State of New Mexico  
 Energy, Minerals and Natural Resources

SUNDRY NOTICES AND REPORTS ON WELLS  
 (DO NOT USE THIS FORM FOR PROPOSALS TO DRILL OR TO DEEPEN OR PLUG BACK TO A DIFFERENT RESERVOIR. USE "APPLICATION FOR PERMIT" (FORM C-101) FOR SUCH PROPOSALS.)

2. Name of Operator  
 DEVON ENERGY PRODUCTION COMPANY, LP.

Operator Name: DEVON ENERGY PRODUCTION COMPANY, L.P.	Property Name: SPUD MUFFIN 31-30	Well Number 624H
--	-------------------------------------	---------------------

WELL LOCATION AND ACREAGE DEDICATION PLAT

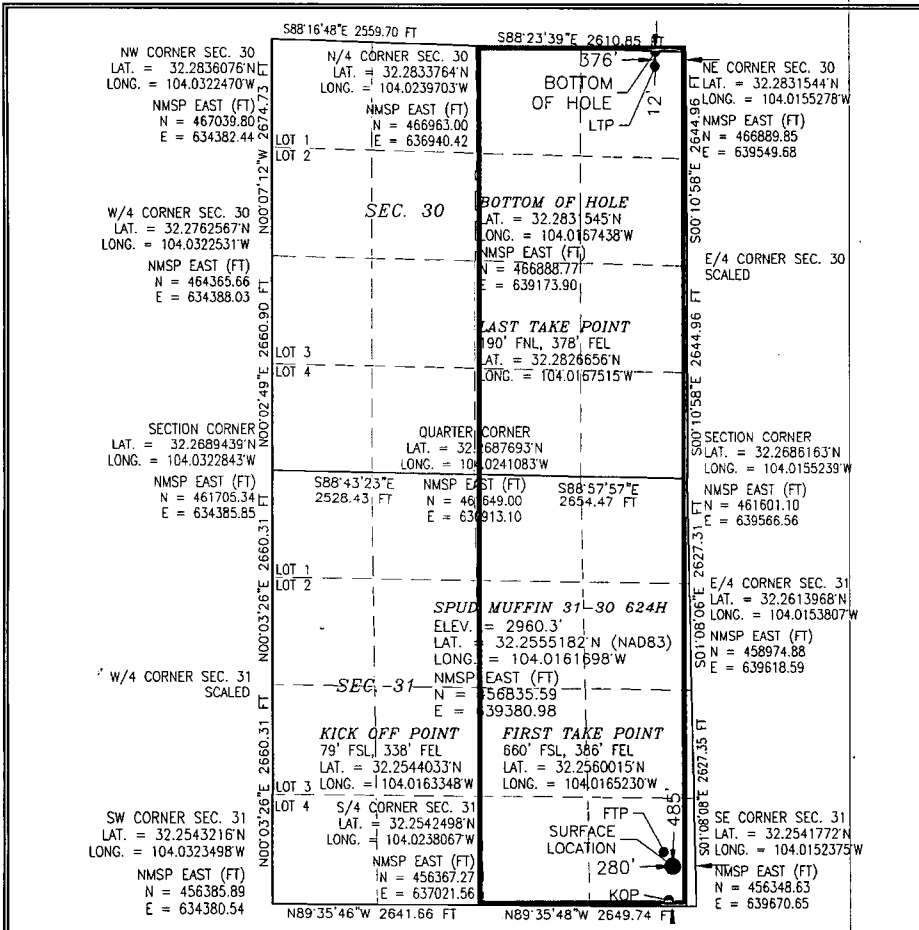
**Devon Energy Production Company, LP respectfully requests approval for a surface hole change per the following:**

**From: Sec. 31, T23S, R29E, 485 FSL 250 FEL**

**To: Sec. 31, T23S, R29E, 485 FSL\ 280 FEL**

**This change occurred during drilling process.**

**Attached: As drilled C-102**
